# Emcore Corporation

## Modification of Comprehensive Stressed Receiver Sensitivity and Overload Test for Verification of Equalizer Adaptation Time

John Dallesasse  
Emcore Corporation  
IEEE 802.3aq Interim Meeting  
May 17-19, Austin, TX

## Revised Figure 68-10

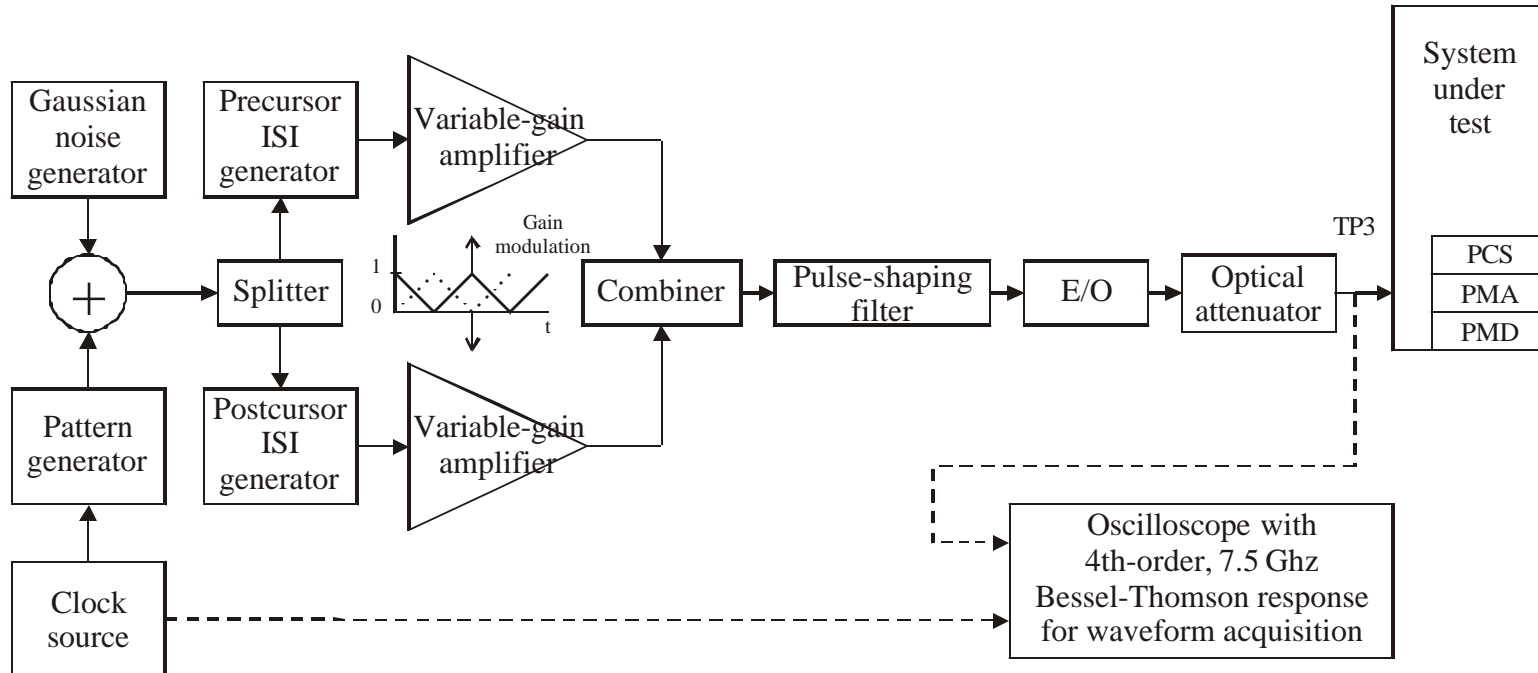
- Slow Time Variation Between Pre-Cursor and Post-Cursor ISI Generators is Created Through Modulating the Gain on Amplifiers at the Outputs of the Generators
- A Triangle Wave Is Suggested for Gain Modulation
  - Maintains Normalized Amplitude of Combined Signal at Constant Value
  - Modulation Frequency at Expected Rate of Change Channel Impulse Response – Suggested Value is 50 Hz
- **Current Comprehensive Stressed Receiver Sensitivity and Overload Test May Still be Performed as Separate Test**

Note: "Precursor ISI generator" and "Postcursor ISI generator" could be generalized to "ISI generator 1" and "ISI generator 2"

- **Add to Section 68.6.9.1:** “For the Comprehensive stressed receiver and overload test without equalizer adaptation time testing, one variable-gain amplifier is set at constant gain, while the other is set for high attenuation.”
- **Add Section 68.6.9.5: Equalizer adaptation time test procedure**
- **Add Row to Table 68-5 – Patterns 2 or 3**
